OCTOBER 9, 2025

BOARD OF COMMISSIONERS REGULAR PUBLIC MEETING

**RE: Executive Summary for LD-25-01 – 1526 Fairview Avenue
PARID: 30-00-18860-00-1/ TMID: 30196 017
Preliminary/Final Major Subdivision & Land Development Plans Review (2nd Submission)**

RE: LD-25-01 – 1526 Fairview Avenue
PARID: 30-00-18860-00-1/ TMID: 30196 017
Preliminary/Final Major Subdivision & Land Development Plans Review (2nd Submission)

PLAN

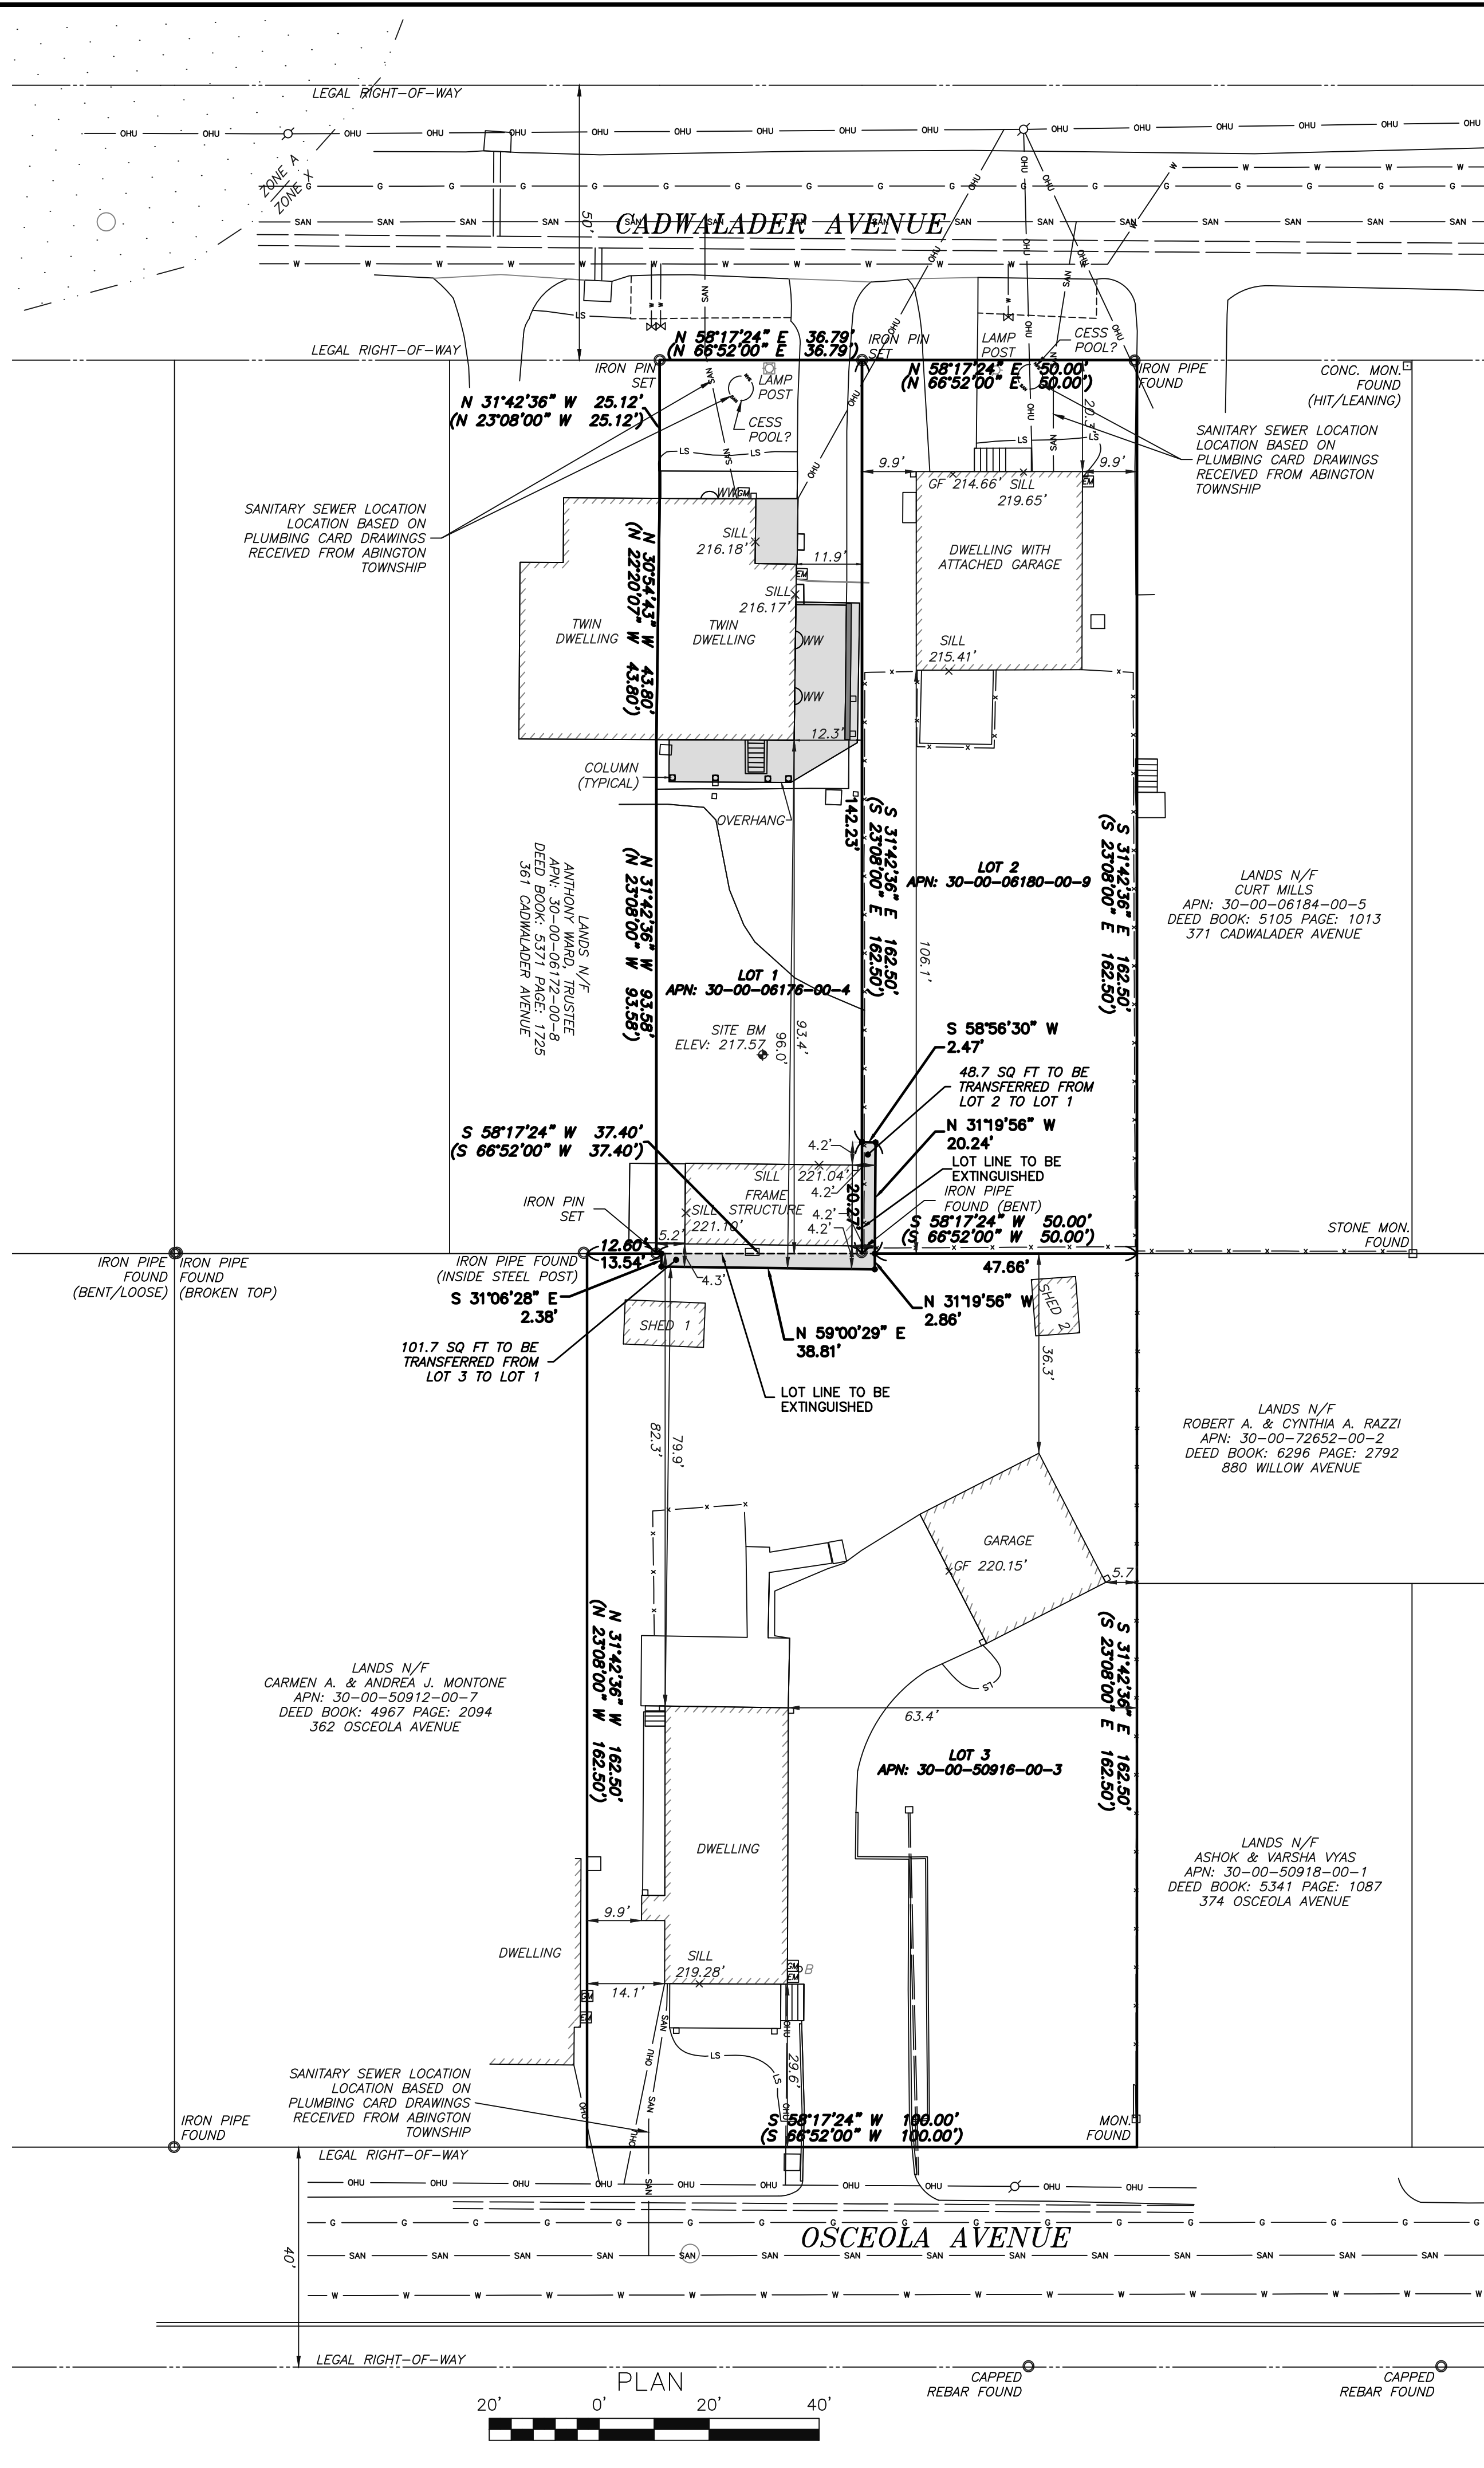
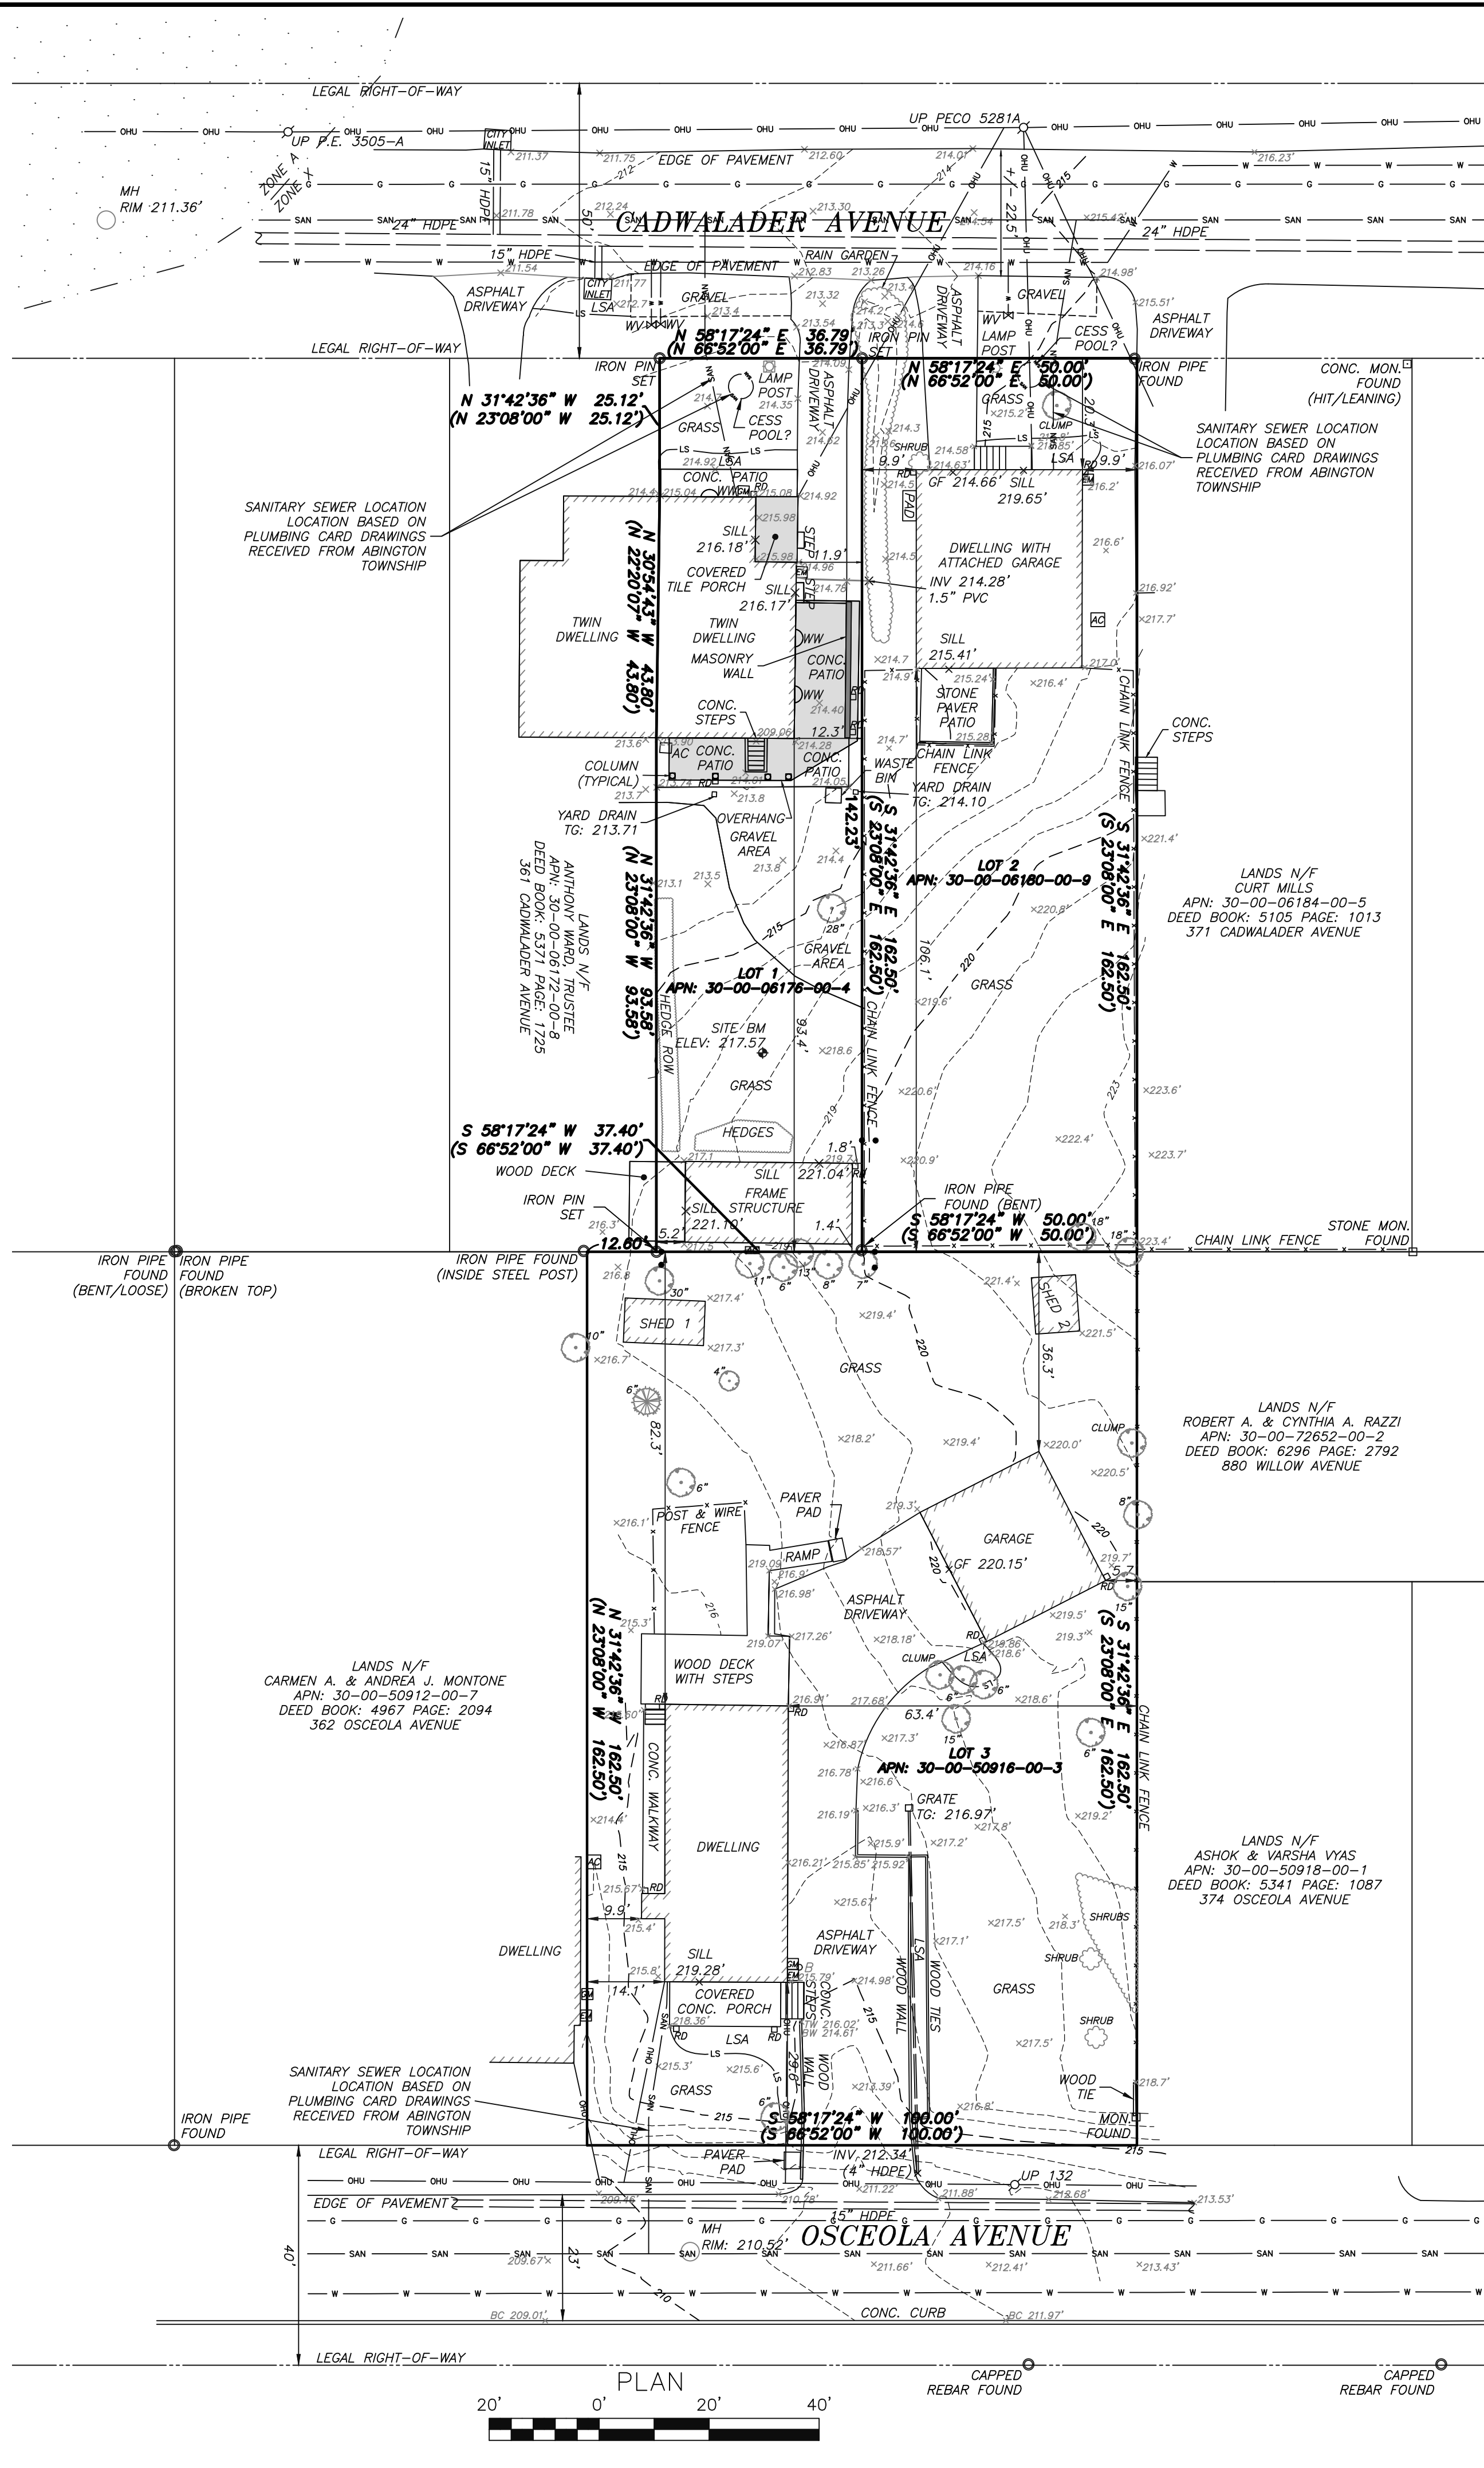
2. **Per §1302 Figure 13.1 – Dimensional Regulations** – The Applicant has provided dimensional regulations on the plans; however, the requirements for the R-4 Medium-High-Density Residential Zoning District are provided as opposed to the requirements for the RC Recreation/Conservation Zoning District. The zoning data table shall be revised to reflect the regulations for the RC Recreation/Conservation Zoning District and the plans and table updated accordingly to list any existing non-conformities.
